RE: Draft Discharge Permit, DP-1840, Copper Flat Mine

NMED has imposed additional conditions on DP-1840 that are not requirements of the Copper Mine Rule (20.6.7 NMAC). Pursuant to Subsection I of 20.6.7.10 NMAC, NMED is providing the following written explanations of the reasons for the additional conditions.

Figure A1. Projected groundwater drawdown 100 years after mining.

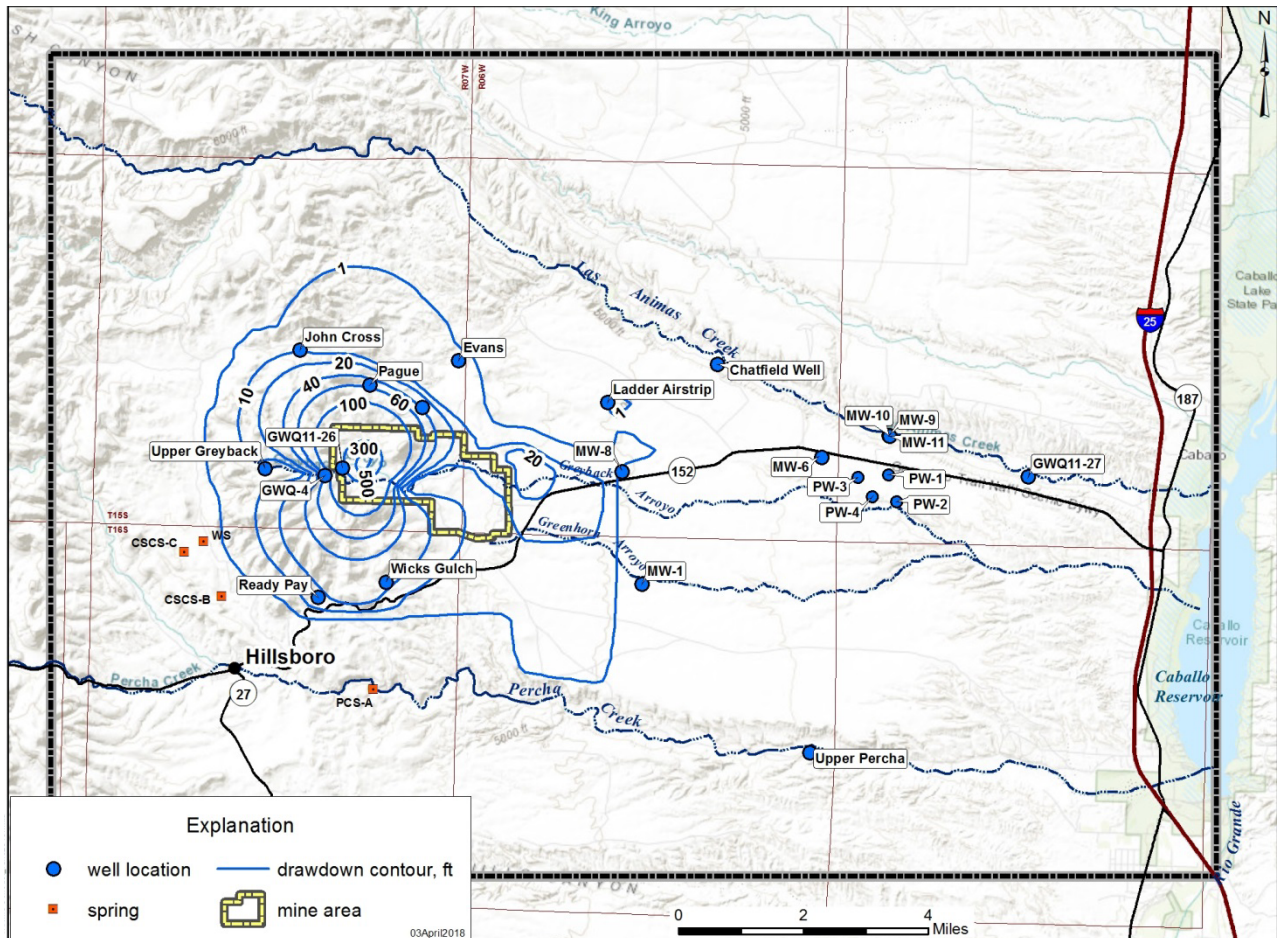
4. The drawdown contour intervals of Figure 3.12 versus Figure A1 are different. Please include an approximate 1 foot drawdown contour on Figure A1 to allow for comparison of the end-of-mining drawdown versus the anticipated effects 100-years after mining.

5. Figure A1 appears to show propagation of the pit cone of depression within the crystalline aquifer post-mining. At about 40 to 50 years post-mining, the propagation of the cone of depression seems to diminish (i.e. see Figure A23, projected water levels at Ready Pay well). Please comment on this apparent propagation including how the water levels are projected to stabilize over time.

4. The drawdown contour intervals of Figure 3.12 versus Figure A1 are different. Please include an approximate 1 foot drawdown contour on Figure A1 to allow for comparison of the end-of-mining drawdown versus the anticipated effects 100-years after mining.

5. Figure A1 appears to show propagation of the pit cone of depression within the crystalline aquifer post-mining. At about 40 to 50 years post-mining, the propagation of the cone of depression seems to diminish (i.e. see Figure A23, projected water levels at Ready Pay well). Please comment on this apparent propagation including how the water levels are projected to stabilize over time.

Figure 3-1: 2017 MORP Pit Showing Expanded 4900 Catch Bench and Pit Surfaces Scheduled for Cover

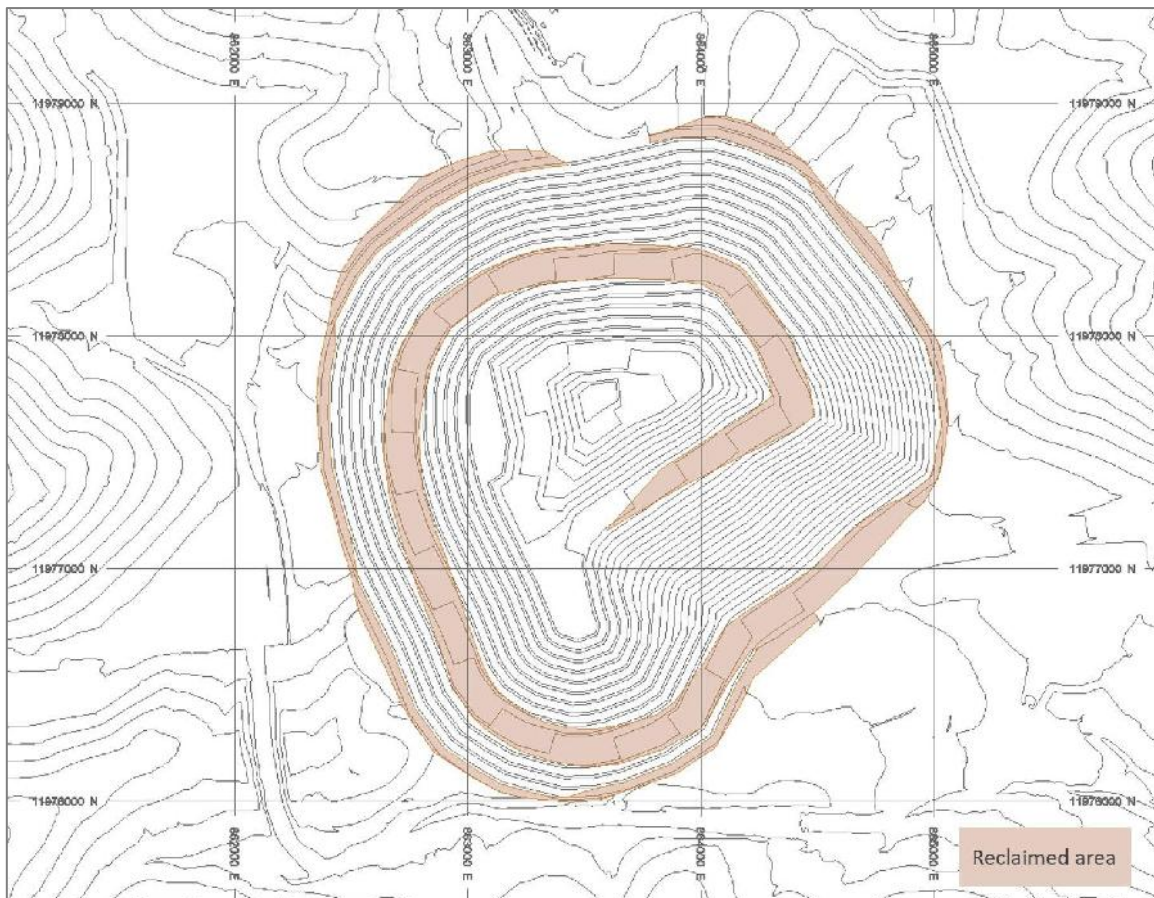
8. Section 3.1.8 and Figure 3-1 indicate that the pit bottom will be covered with a suitable reclamation material before pit flooding occurs, however the October 13, 2017, amendment to the Mining Operation and Reclamation Plan ("MORP") submitted by NMCC does not propose to place reclamation materials below the waterline of the future pit lake. As stated in Section 6.2, the covered and submerged portions of pit reclamation are excluded from the surface area available (Table 6-1) for leaching, and therefore the pit lake modeling results presented in Section 6.6. It is MMD's opinion that any pit surface area exposed before submerging will likely be available to leaching. NMCC should plan to cover as much of the pit surface area as possible after mining to limit the amount of leaching, even those areas to be submerged. This would assist with reclamation prior to inundation of the pit using the rapid refill proposal. Please address.

Figure 5-1: Conceptual Model for Unreclaimed Pit with Natural Fill

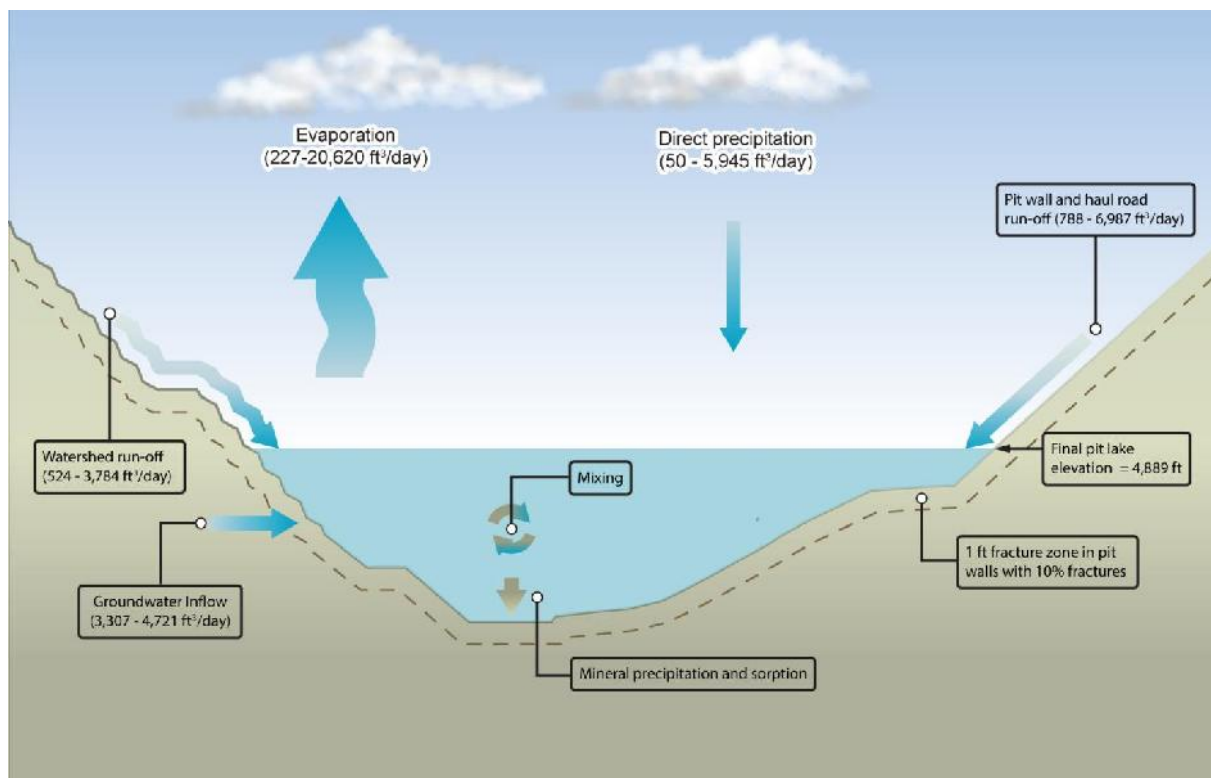
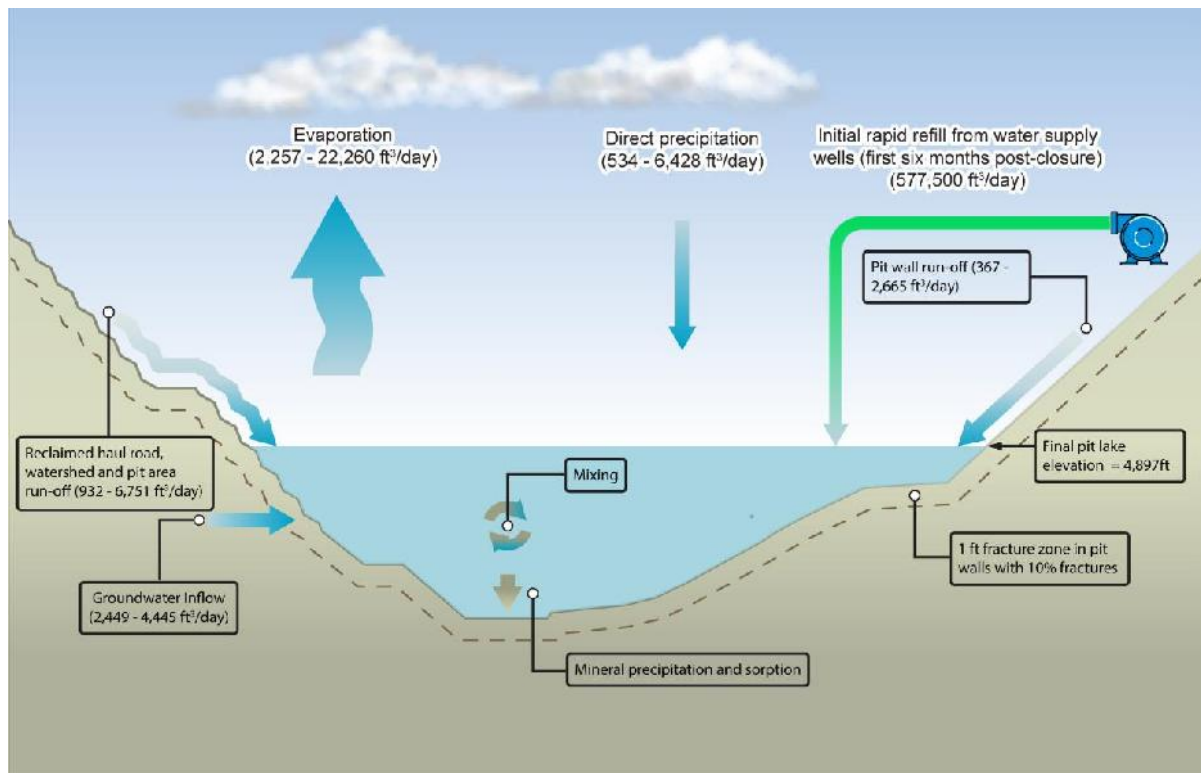
10. Figures 5-1 and 6-1 show different rates of evaporation, direct precipitation, pit wall run-on etc., and a different final pit lake elevation. Please explain the differences between the values presented in these two figures.
